28 August 2024  
Ref: 30N-24-0304-ADM-86563-1

### 1-9 Walkerville Terrace, Gilberton

Vipac Engineers and Scientists completed a wind tunnel test and issued a report in December 2023 on the proposed development at 1-9 Walkerville Terrace, Gilberton (30N-22-0501-TRP-71059-1). Plans of the updated design were supplied in August 2024 from SMFA. A comparison was made with the findings in the December 2023 report. The observations and findings are as follows:

Figure 1: Comparison between the Ground floor plan used for wind tunnel testing (December 2023) and the updated Ground floor plan (August 2024).

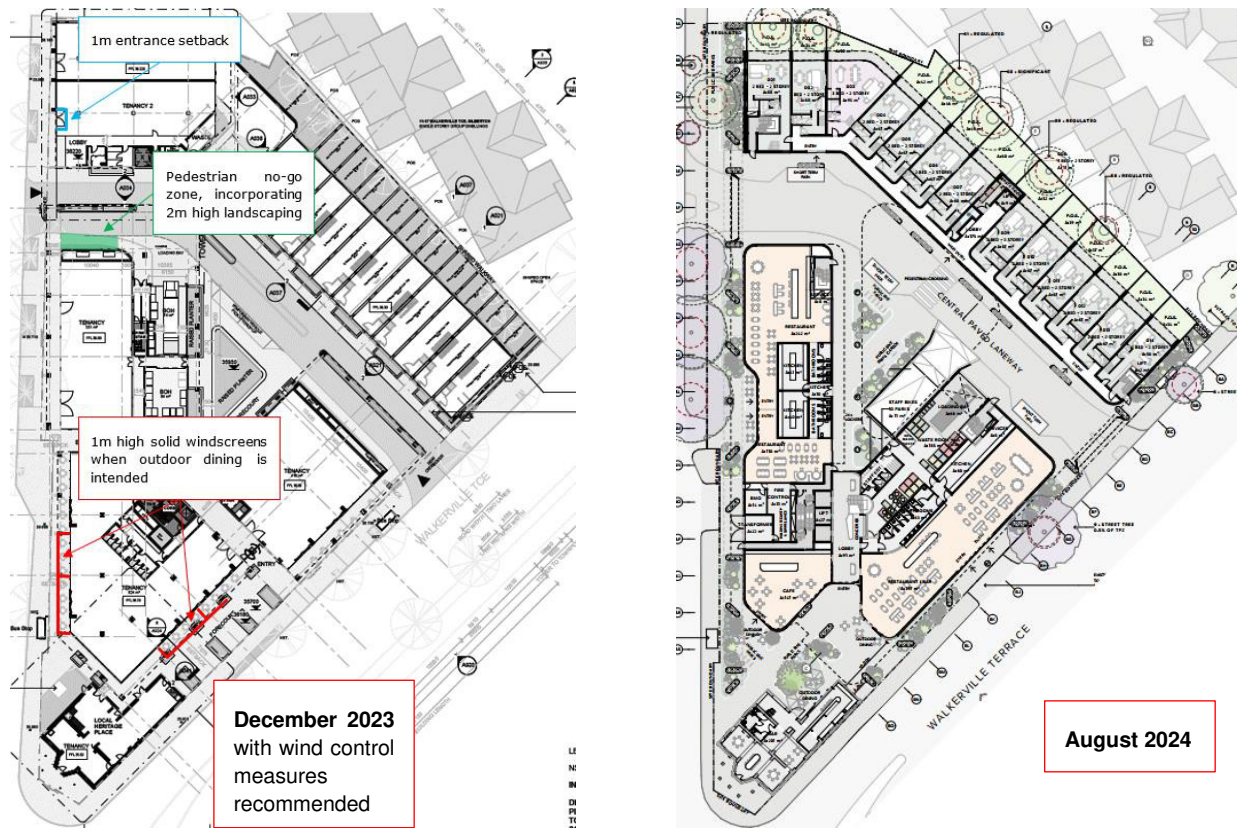
- i) A pedestrian no-go zone incorporating 2m high landscaping at the northern corner of the Mixed-Use Building was recommended in the wind report. This location was experiencing high speed winds due to corner acceleration effects. As the corner is now rounded and features a larger colonnade (Figure 1), some of the adverse corner acceleration effects are expected to be alleviated. As such, wind speeds here are expected to be within the recommended walking comfort criterion, and the previous recommendation is no longer deemed necessary;

- ii) A setback to an entrance west of the previous Commercial Building was recommended in the wind report. This entrance has been removed in the updated drawings (Figure 1) and, as such, the recommendation is no longer deemed necessary;

- iii) Several entrances have been proposed along the Central Paved Laneway (Figure 1). Some of these locations measured wind speeds exceeding the recommended standing comfort criterion for entrance (locations 38 and 41 in the wind report). However the wind tunnel tests were performed without any landscaping. In consideration of the 3-5m high landscaping proposed at these locations (Figure 2), comfortable wind speeds are expected. As such, no further amelioration is required.

- v) 1m high solid windscreens were recommended in the wind report for the outdoor dining areas to the southwest along the building façade. The arrangement and location of the dining areas have been altered in the updated drawings (Figure 1), and are now shielded by:
  - Colonnades;
  - Landscaping; and
  - Located within an inset.

Figure 3: Comparison between the Level 2 plan used for wind tunnel testing (December 2023) and the updated Level 2 plan (August 2024).

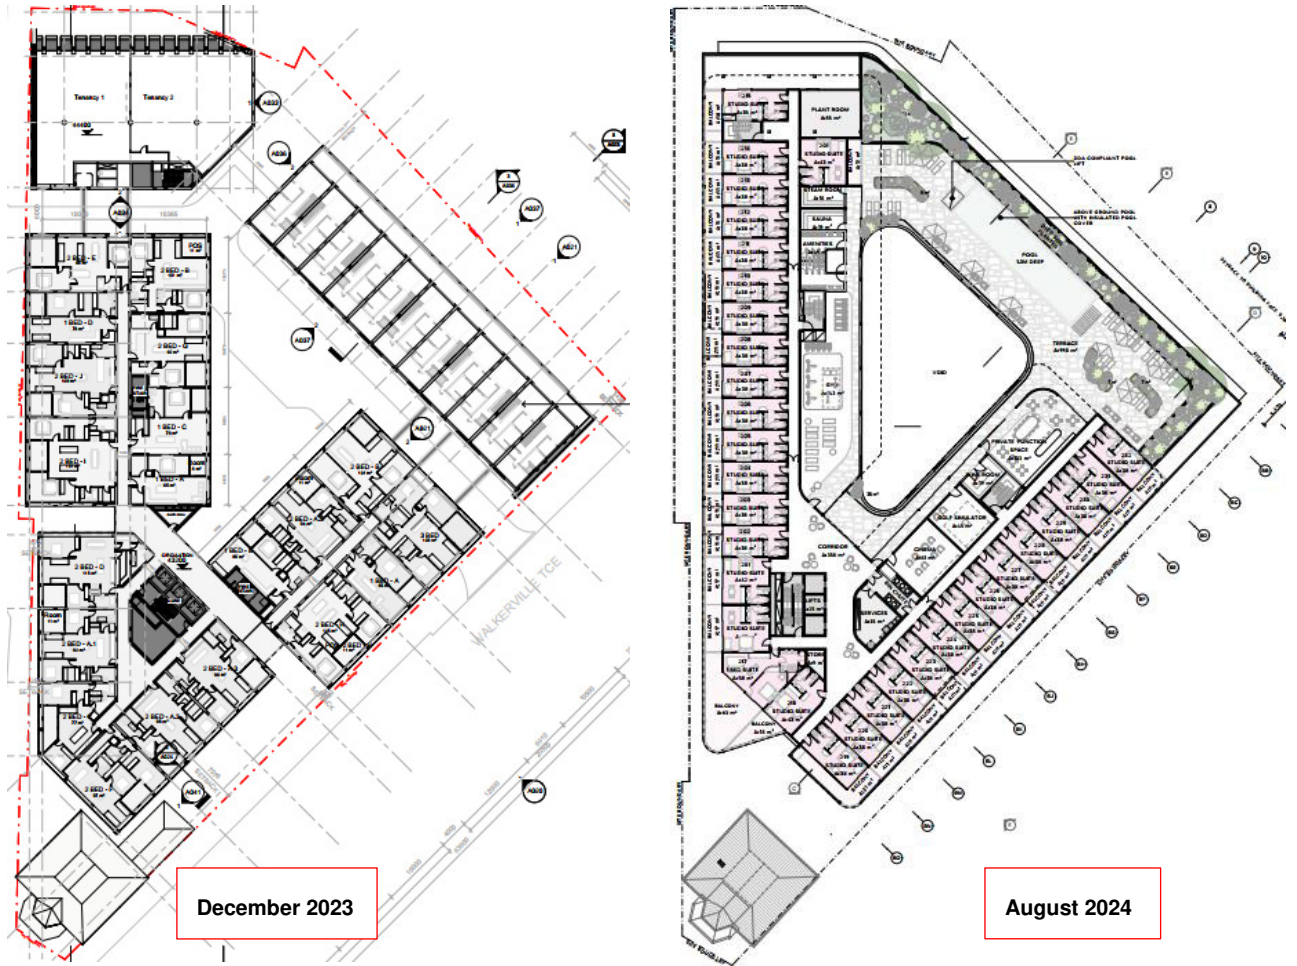
- vi) A communal terrace with a swimming pool is now featured on Level 2 at the north (Figure 3). This terrace is inset, features 1.2m high solid balustrades and landscaping (Figure 4). Some elevated winds may be experienced due to suction through the void, however, wind speeds are not expected to exceed the recommended walking comfort criterion.
- vii) Due to the small dimensions and 1.2m high solid balustrades of the private balconies, wind speeds at these locations are expected to be within the recommended walking comfort criterion.
- viii) The overall maximum height of the development has remained the same at 31.85m (Figure 5).
